Access Compliance Report

Public Rights-of-Way

Intersection ID: 47400	Main Street: OVERLAND_PARK_LN	Cross Street: FLAT_RIVER_DR	Location: NW
ADA ID: 82113B934289	Ramp Type: Perp	Initial Pass/Fail: Fail	Overall Compliance: No
Severity Score: 26.25			
Codes/Mitigation Info/Possible Solution		Field Measurements/Component Compliance

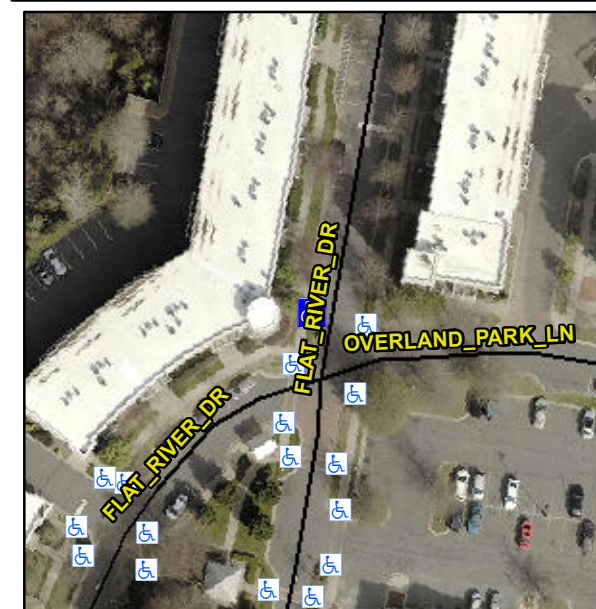
R304.2.2, R304.5.3

Compliance	Description	Data	Compliance	Description	Data
N/A	Ramp Length (in)	57.0	No	Ramp Slope (%)	12.1
Yes	Ramp Width (in)	50.5	No	Ramp XSlope (%)	2.3
N/A	Flare Type LT	N/A	N/A	Flare Type RT	N/A
N/A	Flare Slope LT (%)	N/A	N/A	Flare Slope RT (%)	N/A
N/A	Flare Traversable LT?	N/A	N/A	Flare Traversable RT?	N/A
N/A	Landing Length (in)	N/A	N/A	DWS Provided?	N/A
N/A	Landing Width (in)	N/A	N/A	DWS Contrast?	N/A
N/A	Landing Slope (%)	N/A	N/A	DWS Length (in)	N/A
N/A	Landing X Slope (%)	N/A	N/A	DWS Full Width?	N/A
N/A	Landing Curb? (Y/N)	N/A	N/A	DWS Offset (in)	N/A
N/A	Shared Landing?	N/A			
N/A	Gutter Ponding?	N/A	N/A	Gutter Slope (%)	N/A
N/A	Gutter Lip Ht (in)	N/A	N/A	Gutter X Slope (%)	N/A
N/A	Painted X Walk1?	Yes	N/A	Painted X Walk2?	N/A
	X Walk 1 Direction	To SE		X Walk 2 Direction	N/A
N/A	X Walk 1 Width (in)	51.0	N/A	X Walk 2 Width (in)	N/A
	X Walk 1 Slope (%)	0.9		X Walk 2 Slope (%)	N/A
	X Walk 1 X Slope (%)	1.8		X Walk 2 X Slope (%)	N/A

Remove & Replace Entire Ramp.
